Amendments to the Drawings

Replacement drawing sheets 1 and 2 (containing Figs. 1 and 2, respectively) are attached as an Appendix. The replacement drawings reflect the following changes:

FIG. 2

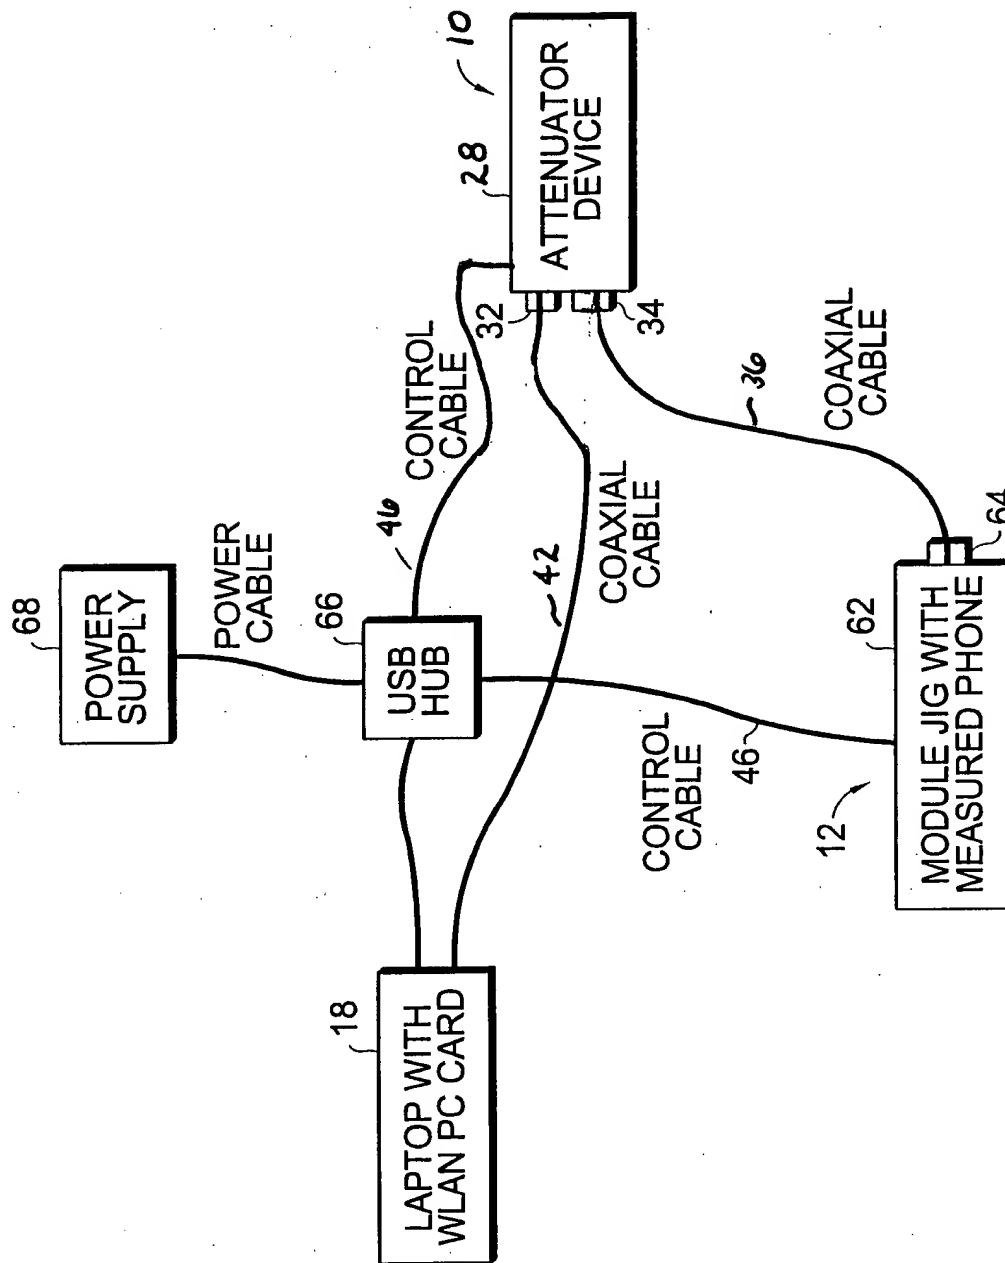
Fig. 2 (sheet 2/3). Reference numerals "10" and "28" have been switched, more correctly representing that variable attenuator 28 is a specific component that is included in test apparatus 10, designated generally. Reference numeral "36" has been added to refer to the coaxial cable from antenna connector 64 to port 34 (*see Specification* at page 12, lines 1-4). Control cable 46 from the USB hub 66 to variable attenuator 28 has been labeled and redrawn to more correctly show it going to the variable attenuator itself rather than port 32. Coaxial cable 42 has also been properly labeled and correctly drawn (from WLAN device 18) to port 32. In general, these changes are made so that Fig. 3 more clearly and accurately illustrates the invention as described on pages 11-12 of the *Specification*.

FIG. 1

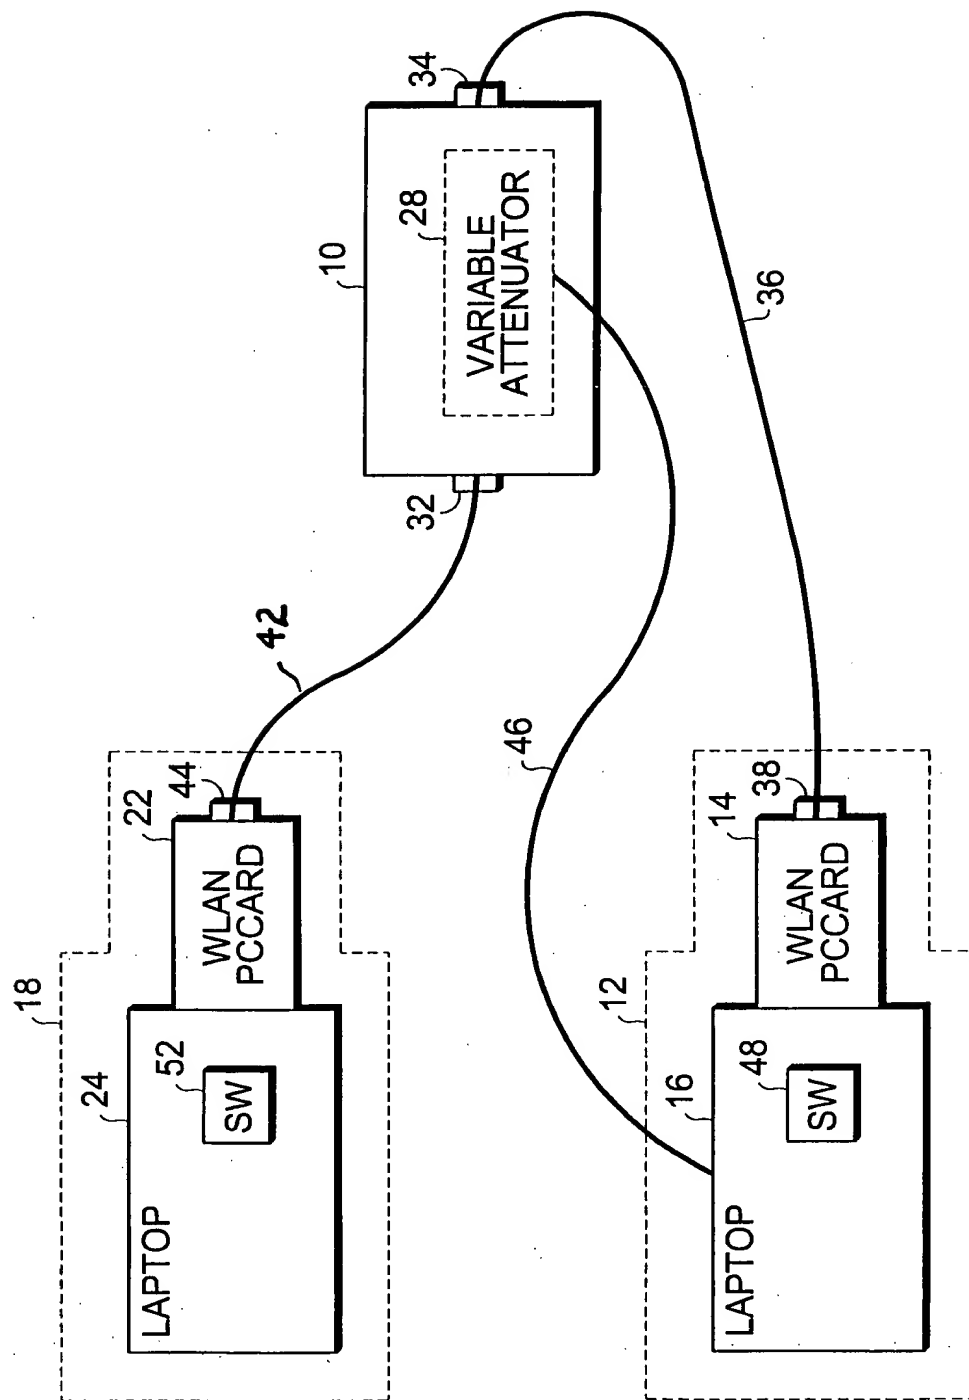
Fig. 1 (sheet 1/3). A line representing coaxial cable 42 (*see Specification* at page 9, lines 12-14) has been labeled with the reference numeral "42".
